FAA Initiative to Address Noise Concerns of Santa Cruz/Santa Clara/San Mateo/San Francisco Counties

Work Group Meeting

September 28 2016

3. Raise altitude at MENLO to 5,000 feet

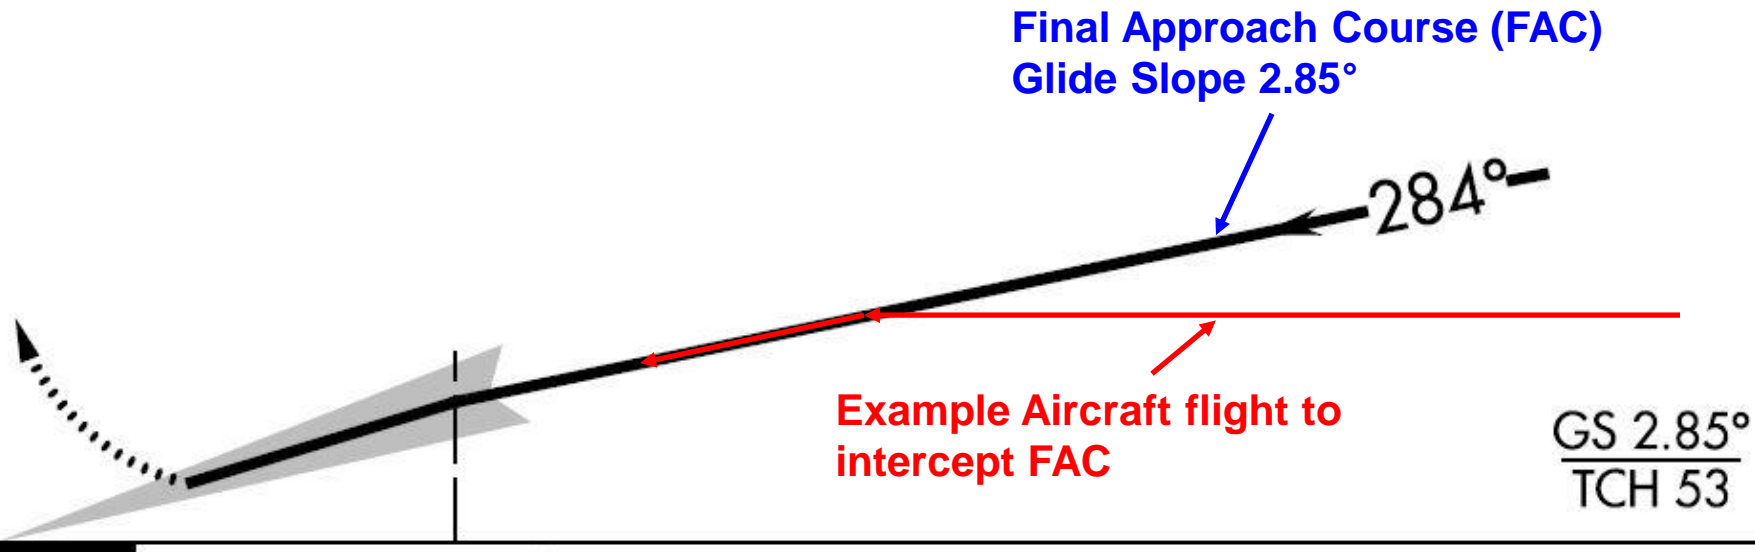
The preferred method to intercept a glide path is from below.

Raising MENLO to 5,000 feet could create an unsafe descent rate, likely causing some aircraft to either join the Final Approach Course from above or be vectored to rejoin the sequence and try again. This would result in a negative safety impact for arriving aircraft.
